Access Compliance Report Public Rights-of-Way (Curb Ramps)

Main Street: SNAPDRAGON_ST		Cross Street: SKLAR_ST		Location:	NW
ADA ID: RPAT211101111131	Ramp Type:Type 1 - Perpendicular	Initial Pass/Fail: Fail	Overall Compliance: No	Severity Score:	16
Codes/Mitigation Info/Possible Solution			Field Measurements/Component Compliance

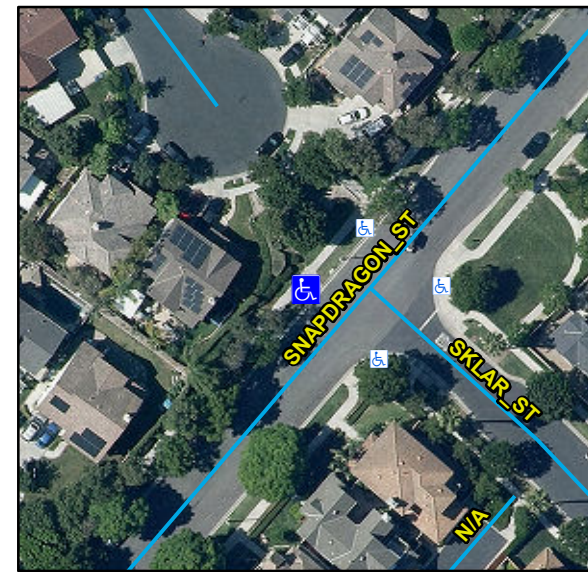
Compliance	Description	Data	Compliance	Description	Data
N/A	Ramp Length (in)	89	N/A	Flare Type LT	
Yes	Ramp Width (in)	50			N/A
No	Ramp Run Slope (%)	8.7	N/A	Flare Slope LT (%)	N/A
Yes	Ramp Cross Slope (%)	0.8	N/A	Flare Traversable LT	N/A
N/A	Landing Present	N/A	N/A	Flare Type RT	
N/A	Landing Length (in)	N/A			N/A
N/A	Landing Width (in)	N/A	N/A	Flare Slope RT (%)	N/A
N/A	Landing Run Slope (%)	N/A	N/A	Flare Traversable RT	N/A
N/A	Landing Cross Slope (%)	N/A	N/A	DWS Provided	N/A
N/A	Landing Movement Obstructed?	N/A	N/A	DWS Contrast	N/A
	Landing Movement Type	N/A	N/A	DWS Length (in)	N/A
N/A	Landing Shared	N/A	N/A	DWS Full Width	N/A
N/A	Clear Space	N/A	N/A	DWS Offset Left (in)	N/A
N/A	Clear Space To Crosswalk (in)	N/A	N/A	DWS Offset Right (in)	N/A
N/A	Marked Crosswalk 1	No	N/A	Marked Crosswalk 2	N/A
	Crossing 1 Direction	SE		Crossing 2 Direction	N/A
	Marked Crosswalk 1 Width (in)	N/A		Marked Crosswalk 2 Width (in)	N/A

Remove & Replace Entire Ramp.

R204.3, R304.2.2, STD 1115
